CITY OF OPELIKA
HISTORIC PRESERVATION COMMISSION
June 8, 2023
4:30 p.m.
Meeting Chambers at Opelika Municipal Courtroom
300 MLK Boulevard

1. 715 Ave D: Geneva Historic District
COA: New Windows
Owner: Pam Pouncy

City of Opelika
Historic Preservation Commission
Staff Report

Agenda Item #: 1
Meeting Date: 04/13/2023
Action Requested: COA: Iron Fence
Location of Property: 715 Ave D; Geneva Historic District
Petitioner: Pam Pouncy

Front Windows facing S. 8th Street

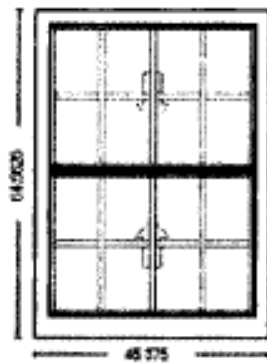
1. Replace four (4) rotten/damaged windows on front and one (1) on rear with AmeriCraft aluminum clad wood double hung SDL windows.

1. Staff recommends approval of replacing all five (5) windows with aluminum clad wood double hung SDL windows.
